Access Compliance Report Public Rights-of-Way (Pedestrian Signals)

Intersection ID: N/A	Main Street:	Cross Street: N/A	Location: N/A
ADA ID: 630727EBF880	Signal Type: Two Push Buttons-Non APS	Overall Compliance: No	Severity Score: BTN 1:N/A BTN 2: N/A No BTN: N/A
Codes/Mitigation Info/Possible Solution		Field Measurements/Component Compliance

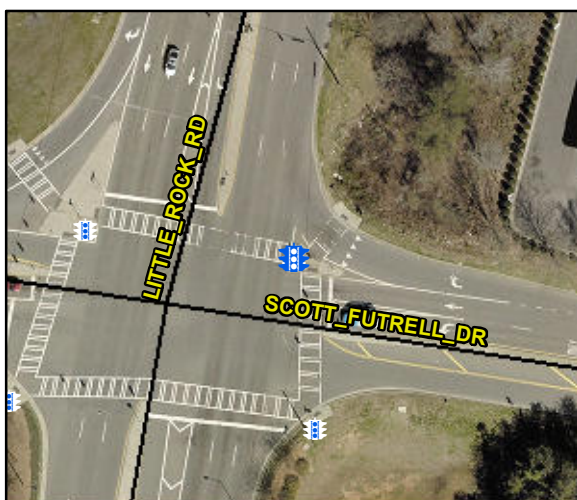
PROW/ADA: R404.2, R404.7.3, R404.7.2, TMUTCD 4e.08, R404.3

N/A	B 1 FWD Approach Width (in)	N/A	N/A	B 2 FWD Approach Width (in)	N/A
N/A	B 1 FWD Approach Obstruction?	Yes	N/A	B 2 FWD Approach Obstruction?	Yes
N/A	B 1 FWD Approach Obstruction Dist (in)	3.0	N/A	B 2 FWD Approach ObstructionDist (in)	3.0
N/A	B 1 PARA Approach?	Yes	N/A	B 2 PARA Approach?	Yes
N/A	B 1 PARA Approach Constrained?	Yes	N/A	B 2 PARA Approach Constrained?	Yes
No	B 1 PARA Approach Reach (in)	20.0	No	B 2 PARA Approach Reach (in)	33.0
No	B 1 PARA Approach Width (in)	48.0	No	B 2 PARA Approach Width (in)	48.0
N/A	B 1 PARA Approach Obstruction?	Yes	N/A	B 2 PARA Approach Obstruction?	Yes
N/A	B 1 PARA Approach Obstruction Dist (in)	3.0	N/A	B 2 PARA Approach ObstructionDist (in)	3.0
Yes	B 1 Clear Floor Space Slope (%)	0.8	No	B 2 Clear Floor Space Slope (%)	2.5
No	B 1 Clear Floor Space XSlope (%)	4.3	Yes	B 2 Clear Floor Space XSlope (%)	0.3
N/A	B 1 PAR Slope (%)	N/A	N/A	B 2 PAR Slope (%)	N/A
Yes	B 1 Height (in)	35.0	Yes	B 2 Height (in)	35.0

N/A	B 1 Clear Xing Direction?	Yes	N/A	B 2 Clear Xing Direction?	Yes
	B 1 Crossing Direction	To W		B 2 Crossing Direction	To S
Yes	B 1 DistanceTo XWalk (in)	0.0	Yes	B 2 DistanceTo XWalk (in)	0.0
Yes	B 1 DistanceTo Curb (in)	36.0	No	B 2 DistanceTo Curb (in)	14.0
Yes	B 1 Diameter (in)	2.0	Yes	B 2 Diameter (in)	2.0

Possible Solutions: Remove and Replace Clear Space. Replace Signal Push Button With APS Button on New Post. Remove & Relocate Sign.
